ADDENDUM #08

INVITATION TO BID #01

ACES at CHASE

STATE PROJECT NO. 244-0044 MAG

Drawing Number:
A260-4

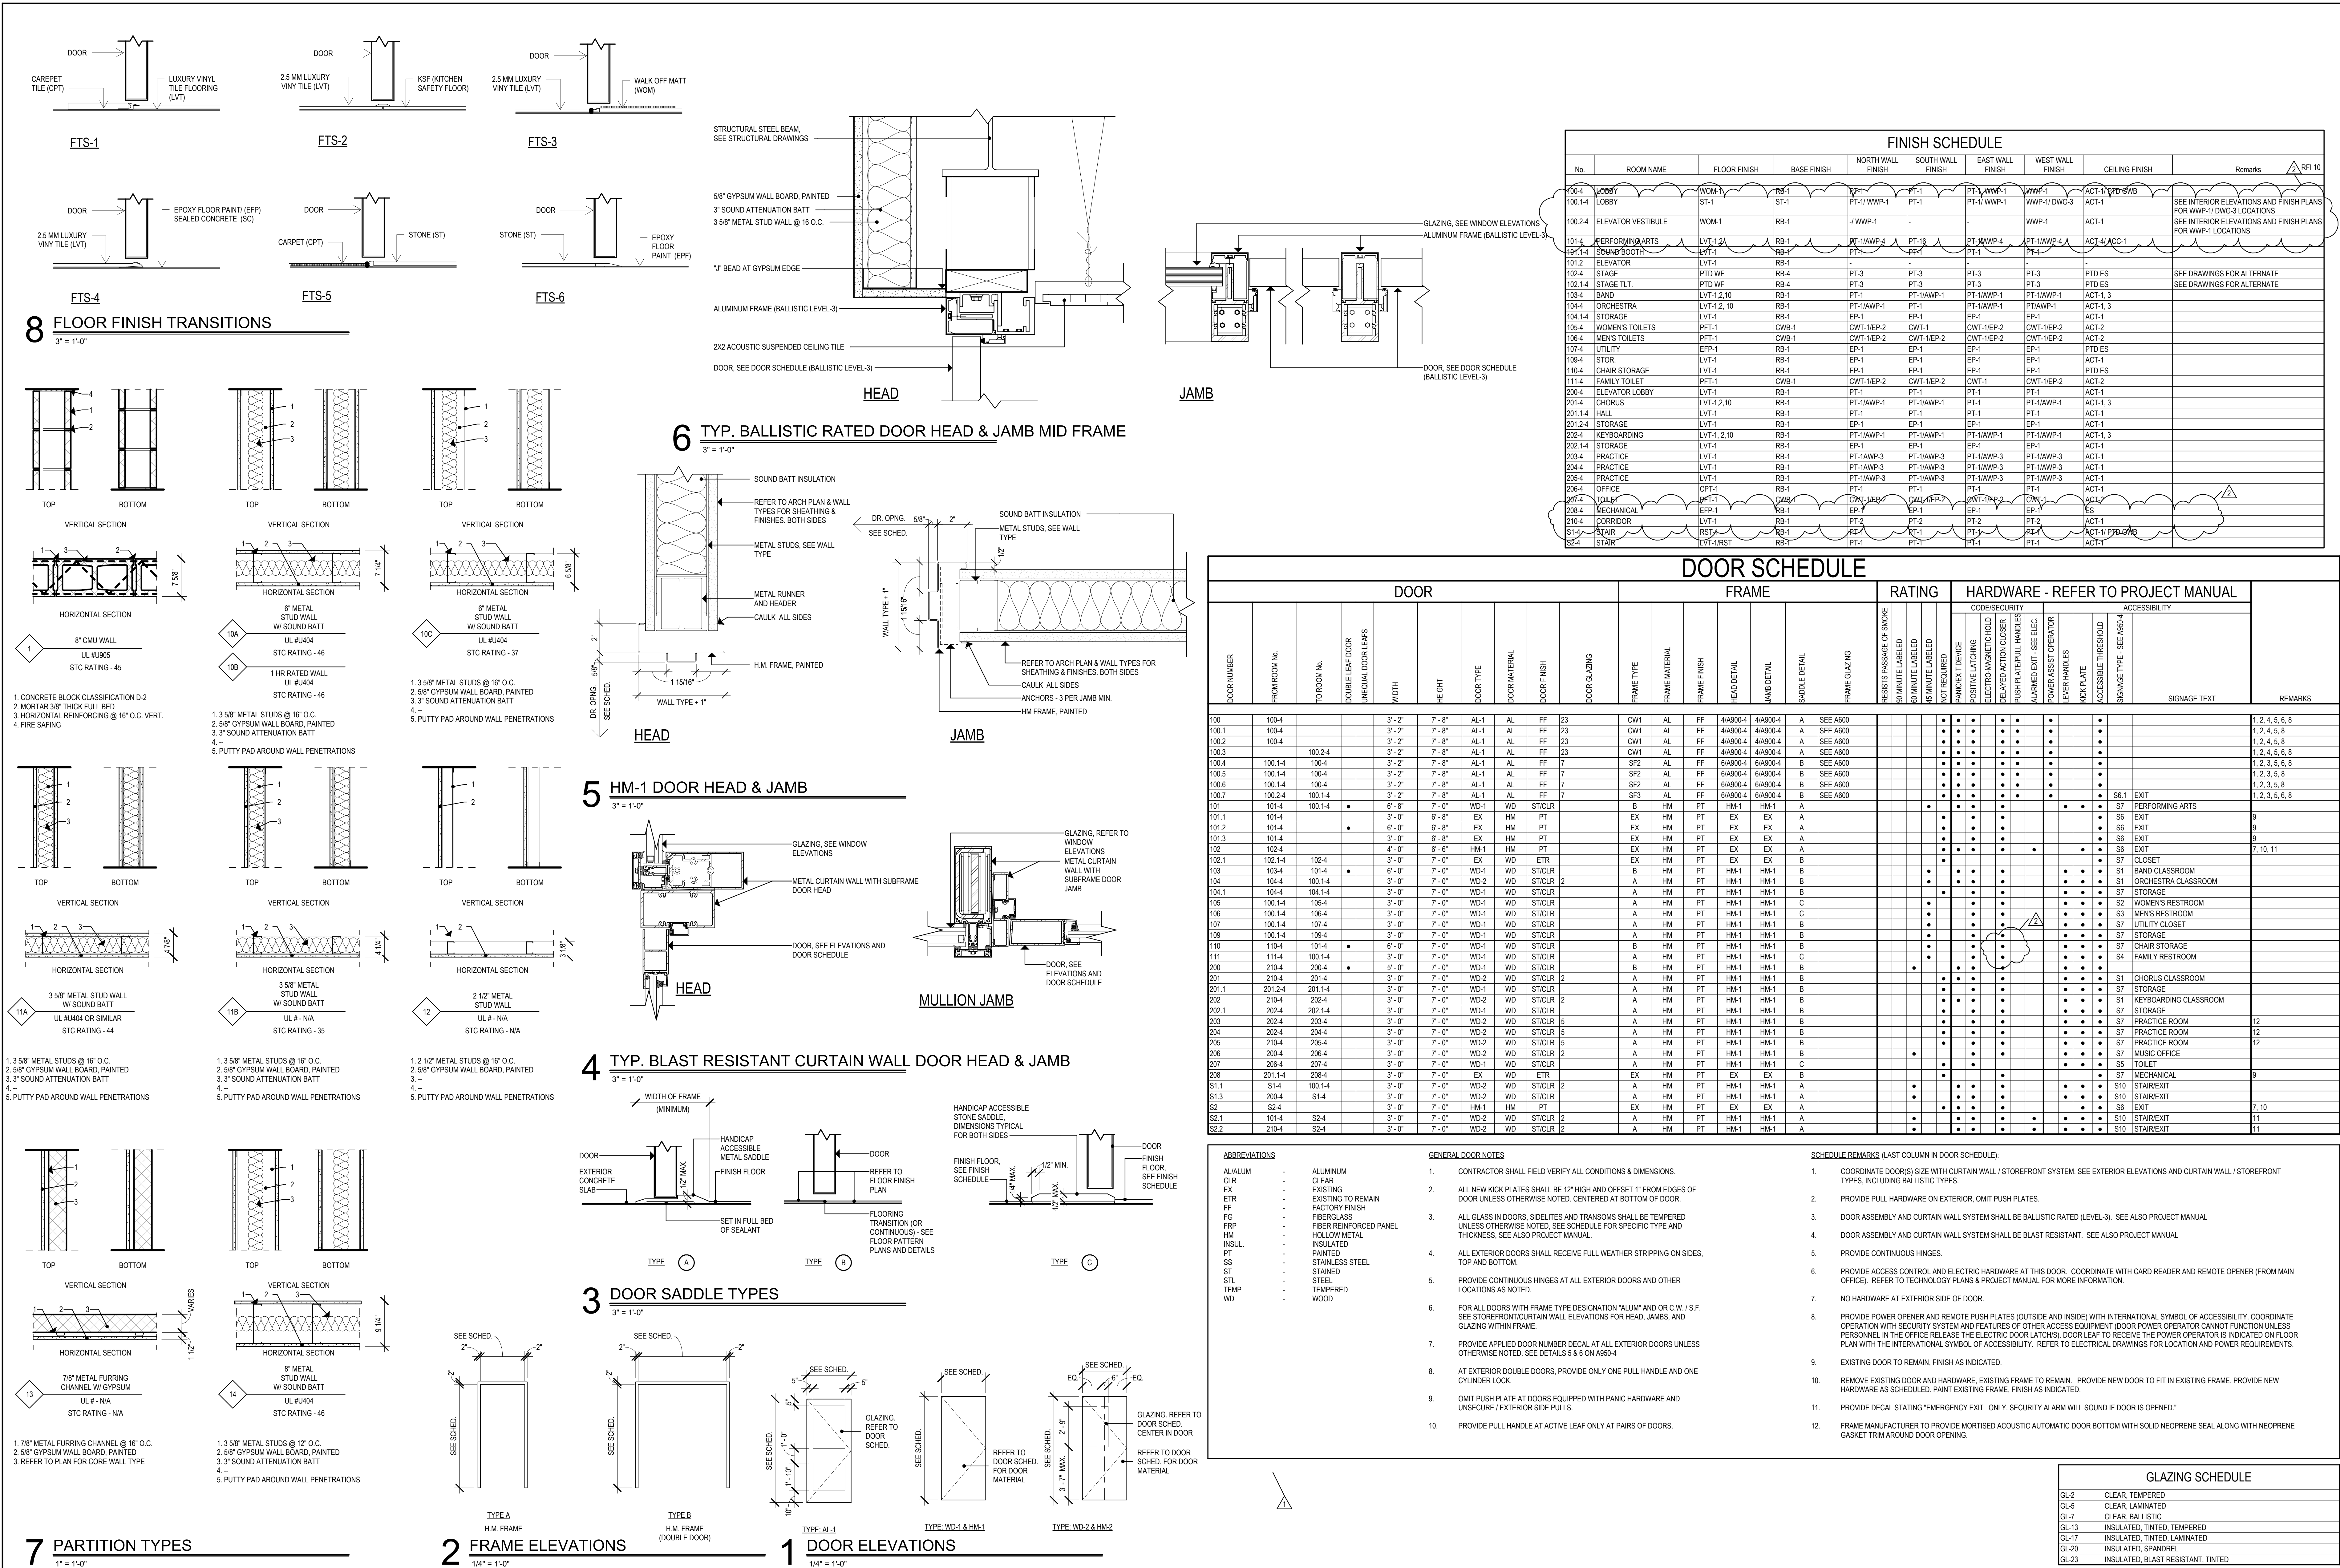
1. Should it extend further right so it abuts the vestibule storefront?
2. Where exactly should it stop at the left-hand side? Plan detail 7/A500 doesn’t indicate the panel system.
3. Are the panels supposed to wrap around the niche to elevator door? Including the head/soffit?
4. Please locate reveal trim.
5. Again, panels extend down to the floor without a base?

Answer: 1.a.i. Correct. Refer to Bulletin #4 for revised Drawing A900-4 and A260-4 to show the extent of WWP-1.
